Federal Register

[Docket No. FAA-2020-0098; Product Identifier 2020-NM-011-AD; Amendment 39-19844; AD 2020-03-20]

Airworthiness Directives; The Boeing Company Airplanes

2020-03-20 The Boeing Company:

Figure 2 to paragraph (g) – AFM – Limitations or Certificate Limitations**Electronics – Global Landing Unit (GLU)****(Required by AD 2020-03-20)**

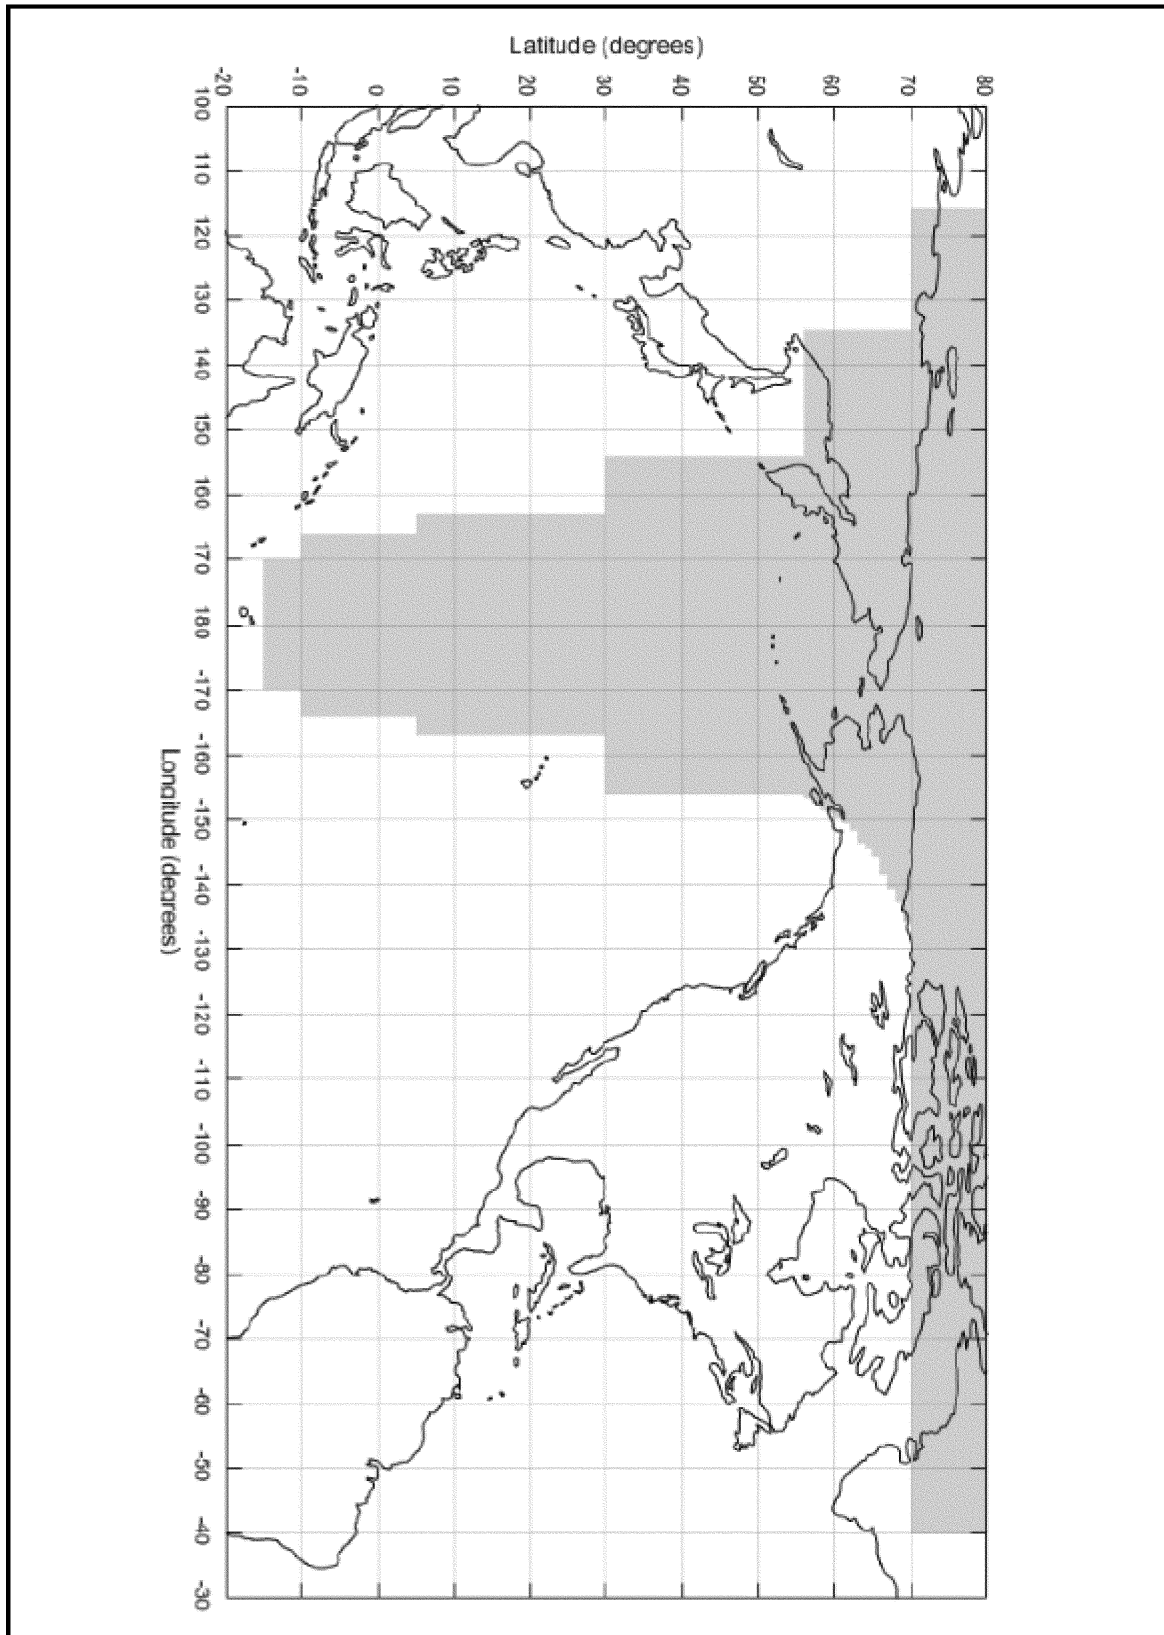
Operations that require less than 0.3 RNP (For example, 0.1, 0.11, 0.15, etc.) in the region identified below are prohibited with GLU-2100 OPS software number COL4D-0087-0002, COL4E-0087-0001, COL48-0087-0700, or COL49-0087-0701 installed.

Exception: Anchorage (PANC) approach procedures that allow less than RNP 0.3 are authorized provided the instructions outlined in the Electronics – Global Landing Unit Section of Normal Procedures Chapter are followed.

Note: Currently, Fairbanks (PAFA) and Anchorage (PANC) are the only airports in the region with an RNP approach that requires better than 0.3 nmi performance.

Region bounded by the following coordinates:

For airplanes equipped with Collins GLU-2100 MMR, part number (P/N) 822-2532-100, having any applicable GLU-2100 operational software (OPS) identified in figure 1 to paragraph (g) of this AD installed: At the applicable time specified in paragraphs (g)(1) and (2) of this AD, revise the limitations or certificate limitations section, as applicable, of the existing AFM to include the information specified in figure 2 to paragraph (g) of this AD and revise the procedures or normal procedures section, as applicable, of the existing AFM to include the information specified in figure 3 to paragraph (g) of this AD. This may be done by inserting a copy of figures 2 and 3 to paragraph (g) of this AD into the existing AFM.
